BOARD ACTION REPORT – APPEALABLE ITEM

Project Name:	8 East Atlantic Avenue
Project Location:	8 East Atlantic Avenue, Old School Square Historic District
Request:	Class II Site Plan Modification, Landscape Plan, Elevations and Certificate of Appropriateness
Board:	Historic Preservation Board
Meeting Date:	April 4, 2018

STAFF REPORT

ITEM: 8 East Atlantic Avenue, Old School Square Historic Arts District – Class II Site Plan Modification, Landscape Plan, Elevations and Certificate of Appropriateness (2018-042) for alterations to the front façade and improvements to the exterior dining area.

North
Elevations

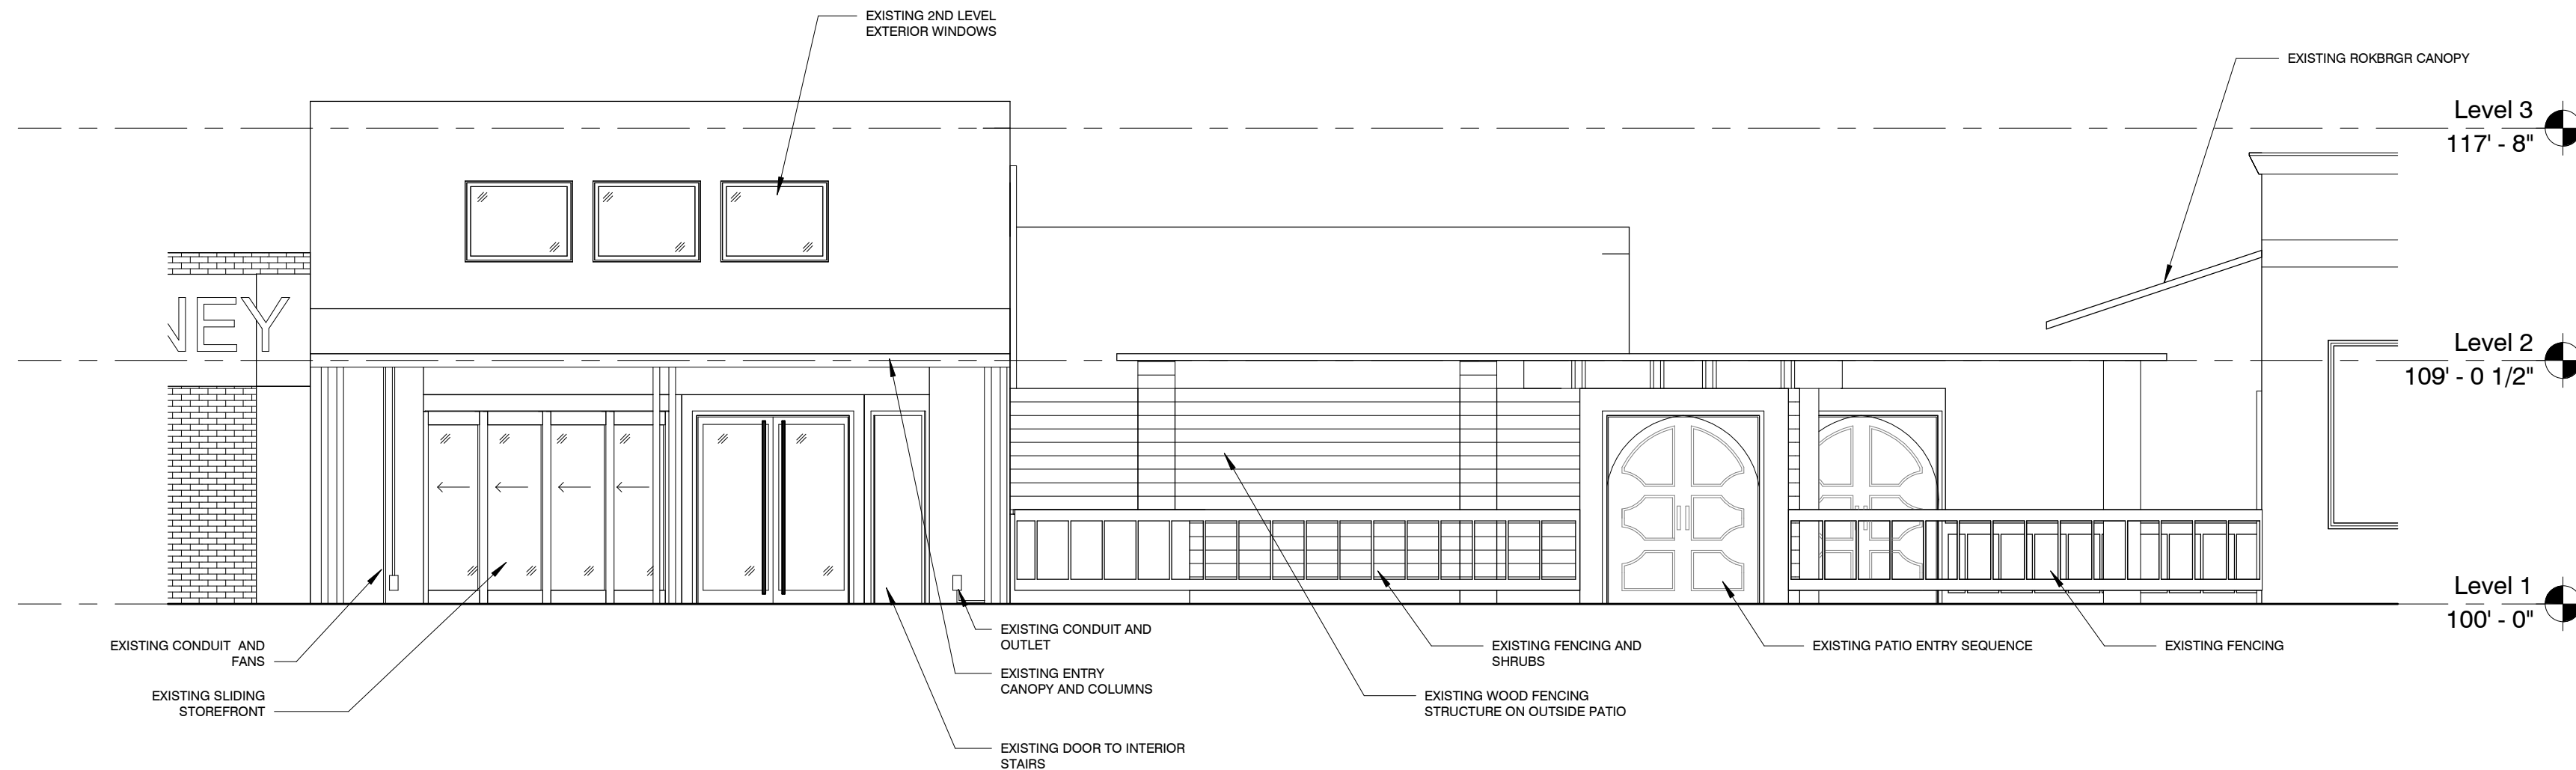
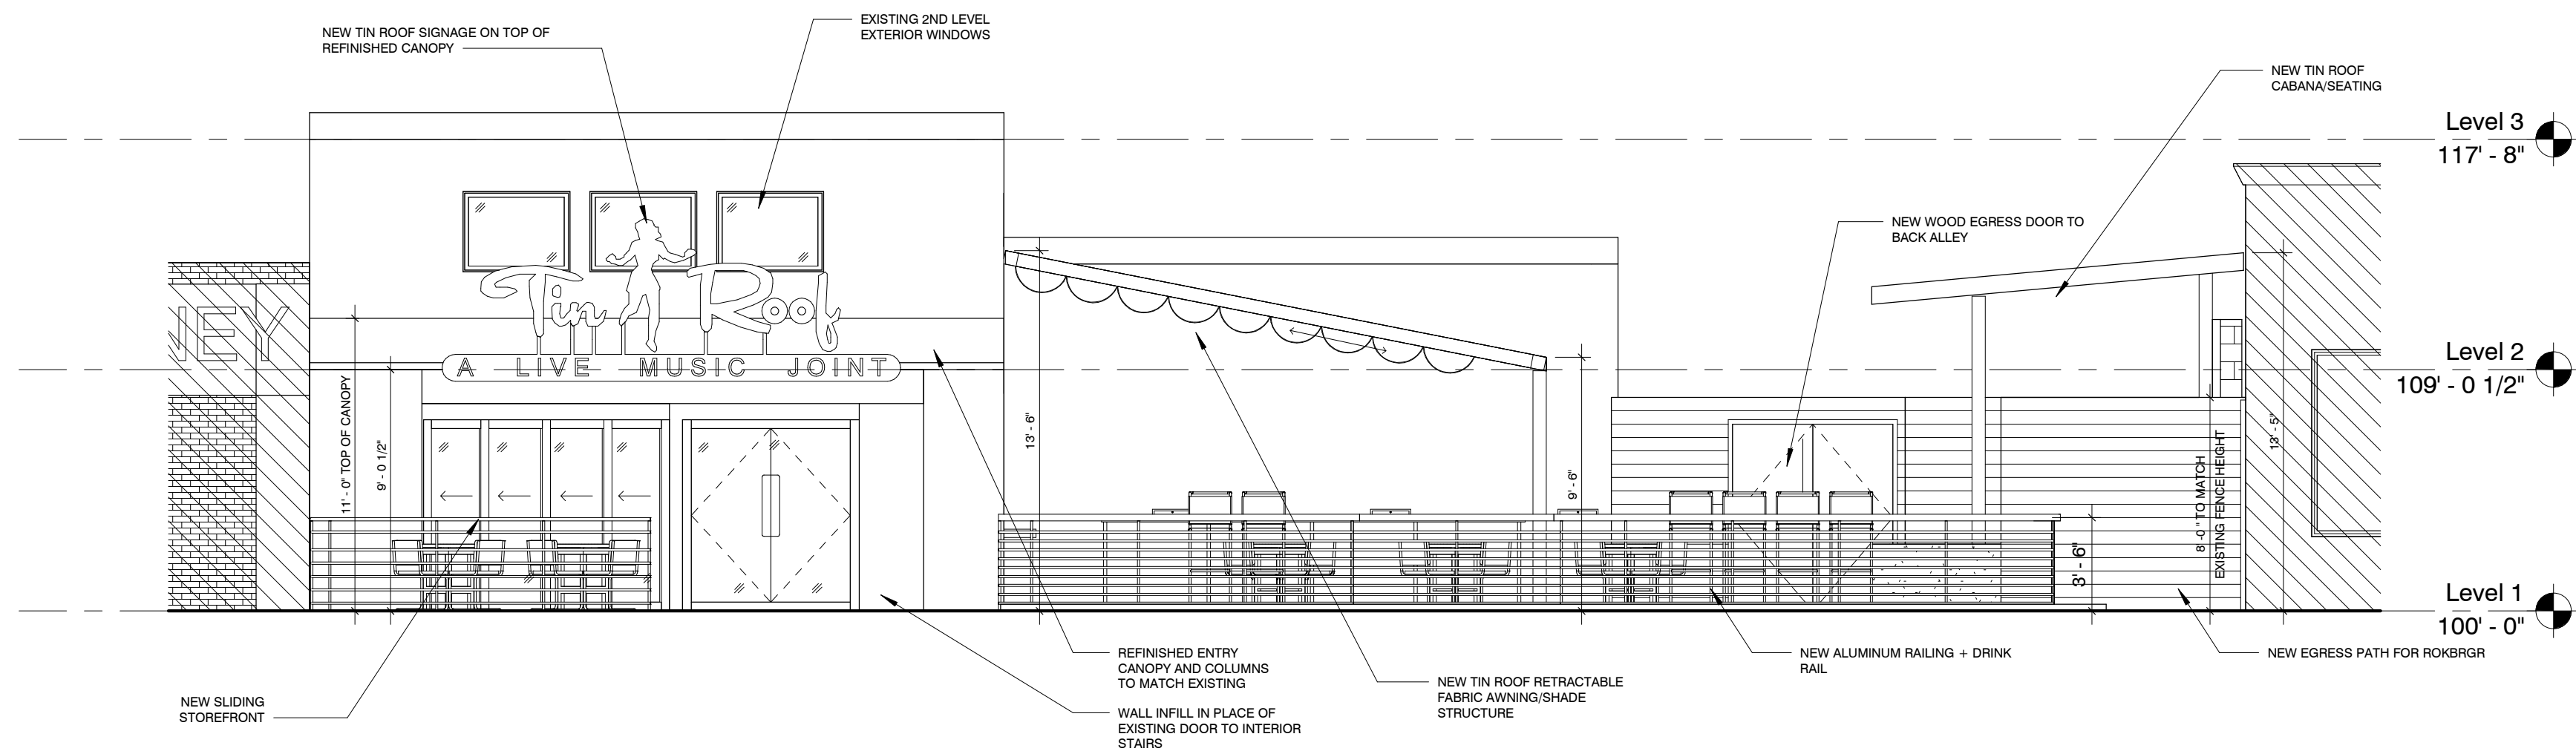
The exterior alterations include new clear anodized aluminum storefront doors (folding glass wall panel system); new canopy on the front façade (North) to be painted in Sherwin Williams "Grays Harbor"; installation of a new horizontal aluminum railing (color will match clear anodized aluminum doors) along the north side of the existing outdoor dining area; and, installation of a 8' wood fence and door on the South side of the property to the rear of the outdoor dining area. Additionally, new cabana is proposed on the West side of the in the outdoor area, this area will also be utilized as an outside platform for performances when needed. The proposal includes installation of a new white, aluminum, pergola with retractable gray fabric shade covering over a portion of the existing outdoor dining area immediately west of the existing building.

The exterior color scheme will be changed to Sherwin Williams "Grays Harbor" and Sherwin Williams "Real Red" exterior walls and Sherwin Williams "Greek Villa" wall trim. The spaces that characterize the property are being preserved by maintaining indoor seating and the exterior dining area. The exterior alterations to the non-contributing structure are compatible with the massing, size, scale, and architectural features in the Old School Square Historic District (OSSHD). The proposal meets the applicable standards noted above and their intent as the proposed changes ensure appropriate alterations to the exterior of the structure. Overall, the proposed changes protect the historic integrity of the existing structure and its environment by allowing modernization of the structure with durable materials.

The paint pattern of the building exterior will include Sherwin Williams “Grays Harbor” and Sherwin Williams “Real Red” exterior walls and Sherwin Williams “Greek Villa” wall trim. The installation of an 8’ wood fence on the South side of the outdoor dining area is also proposed. The relationship of the materials, texture, and color contribute to the “Old Delray Beach” feeling and atmosphere of the Old School Square Historic Arts District (OSSHAD). The proposal creates a cohesive design by introducing only one architectural style. The proposal meets the intent of the review criteria above; thus, positive findings are made with respect to the sections indicated above.

The project was approved subject to the condition that the exterior color scheme as well as a study of delineations between the first and second floors be brought back to the Historic Preservation Board (HPB) for review and approval.

West Elevations

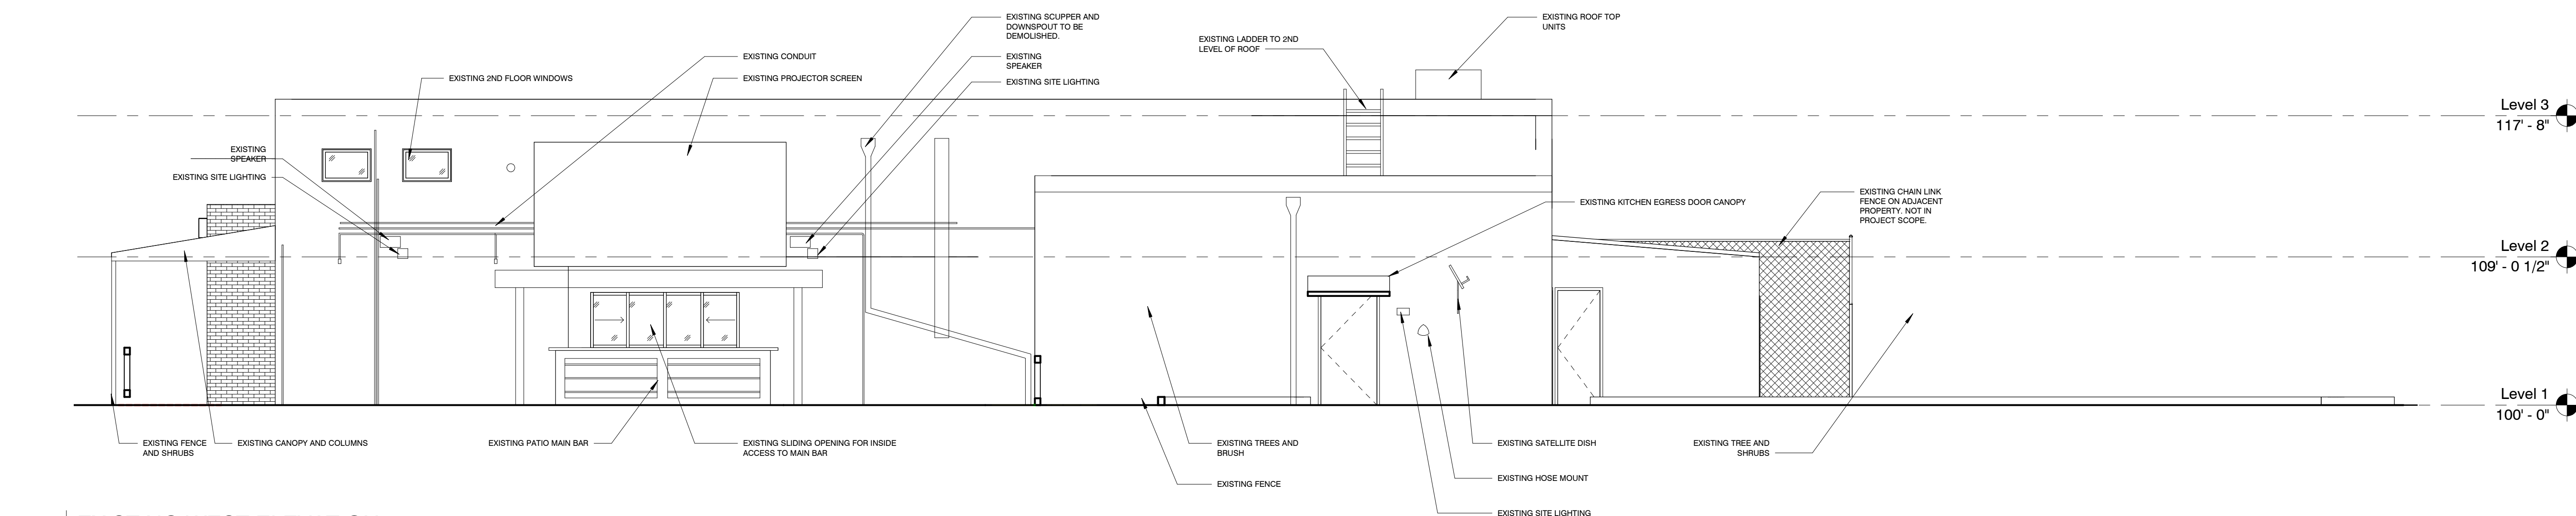
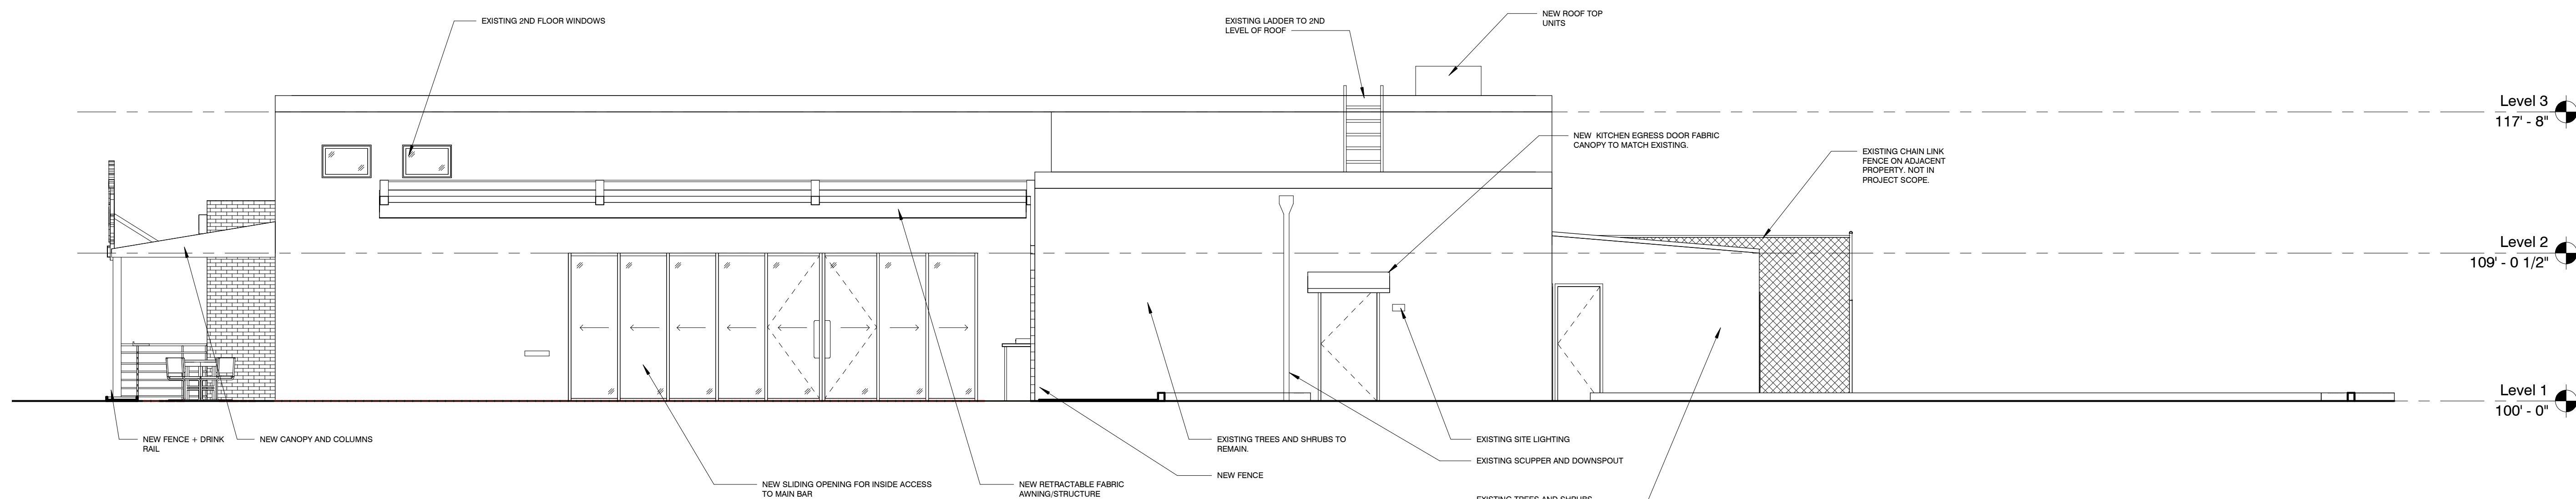
The proposed exterior alterations to the non-contributing structure are appropriate and compatible with the Old School Square Historic Arts District (OSSHAD) and Central Business District (CBD) Architectural Design Guidelines. The new clear anodized aluminum storefront doors (folding glass wall panel system) on the front façade (North) will not modify the existing proportion of openings. The existing fencing and patio entry door will be replaced with a new horizontal aluminum railing on the front façade (North) that will match the color of the clear anodized aluminum doors. A new canopy painted in Sherwin Williams “Grays Harbor” will be installed on the front façade (North). These changes will not substantially alter the existing front façade proportion of the structure. On the West elevation, the new clear anodized aluminum storefront doors (folding glass wall panel system) will require the installation of larger openings than the existing doors. These changes are visually compatible to other restaurants on East Atlantic Avenue that maximize visibility with large windows and glass panel doors. A new white, aluminum, pergola with retractable fabric shade covering and light gray awning is proposed over a portion of the existing outdoor dining area on the West elevation. Also, a new cabana is proposed in the outdoor area on the West side of the property.
